Appl. No. 10/689,380  
Amdt. dated 1 November 2006  
Reply to Office action of 31 August 2006

### **REMARKS/ARGUMENTS**

**Fig.15**

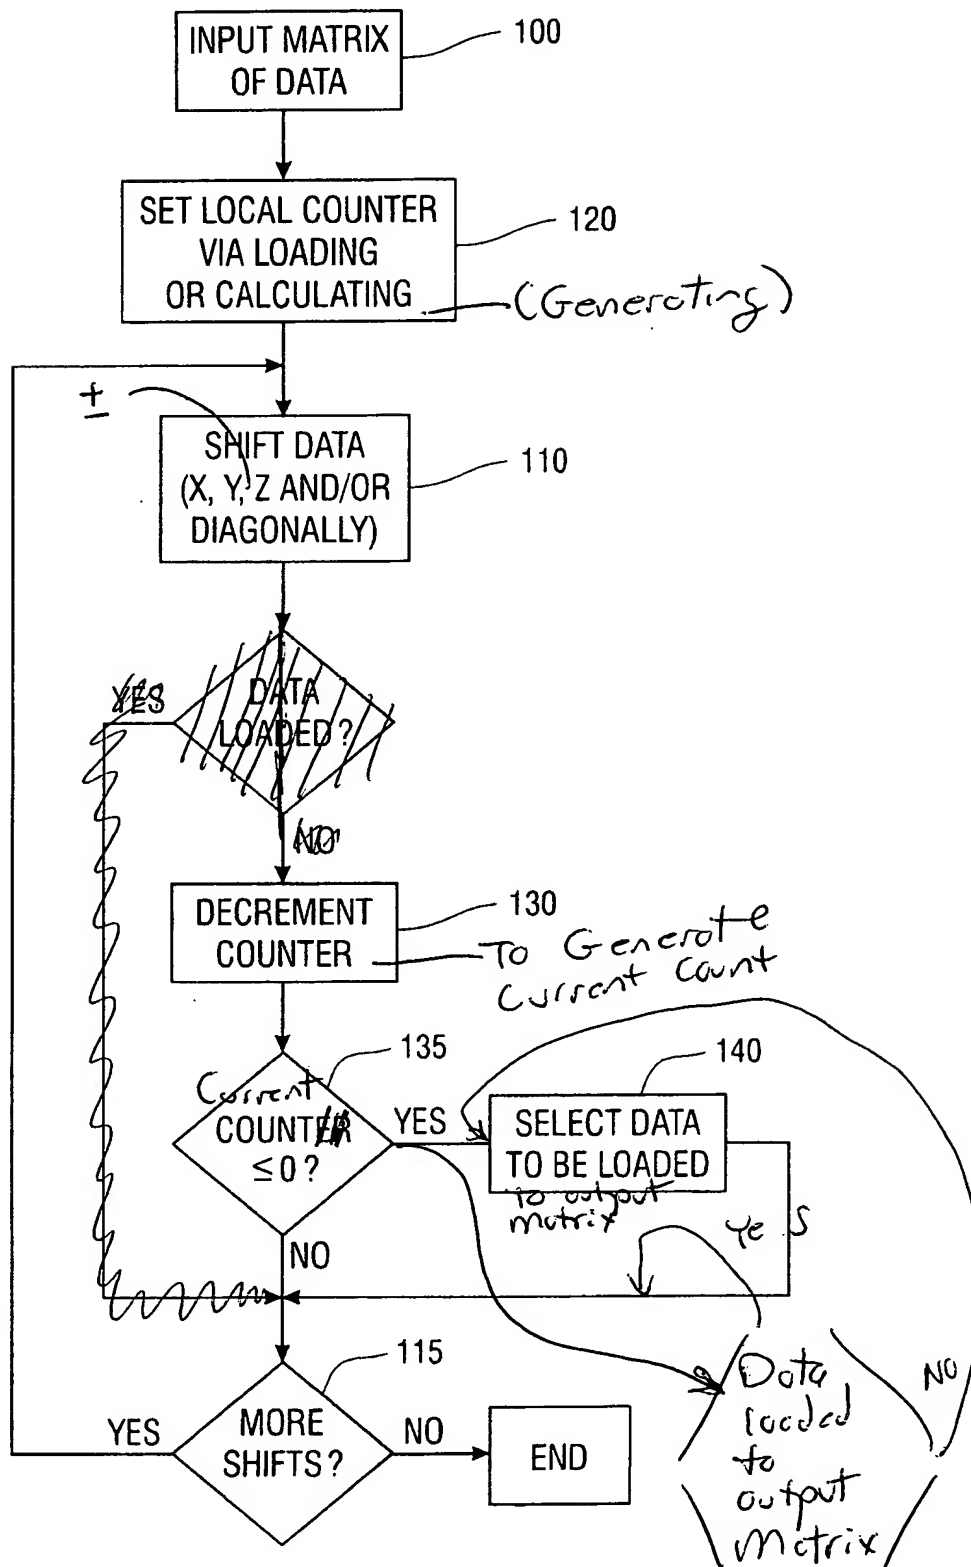
In paragraph 5 of the Office action, the drawings are objected to under 37 CFR 1.83(a) for allegedly failing to show every feature of the invention specified in the claims. A corrected drawing sheet, sheet 7 carrying Fig. 15, is enclosed herewith which addresses each of the examiner's concerns as follows:

The single concern the examiner raised with respect to the introduction of new matter relates to the alleged introduction of new matter by providing "further detail as to when exactly the counter is decremented with regard to the question 'data loaded.'" The question box "data loaded" has been moved so that it now appears between decision box 135 and box 140. Thus, the decrementing of the counter is directly responsive to the shifting of data. That should alleviate the examiner's concern that new matter is being introduced regarding the decrementing of the counter. Support for the decision box "data loaded to output matrix" is found in paragraph 13 which provides "each processing element can conditionally load any of the values it sees into the output result matrix. However, only one value (the desired result) is loaded into the output matrix." The specification clearly provides that only one of the output data is loaded

- generating and [*sic*] the initial count is represented by box 120;
- the current count is represented by box 130;
- the target count comparisons are represented by the decision step 135;
- incrementing/decrementing the current count is represented by box 130;
- shifting data in the positive and negative z direction is represented by box 110; and
- shifting data diagonally is represented by box 110.

to the output matrix. The unnumbered decision block implements the disclosure in the specification.

It is respectfully submitted that replacement sheet 7 of 7 carrying Fig. 15 clearly illustrates all of the features found in the claims without introducing any new matter.
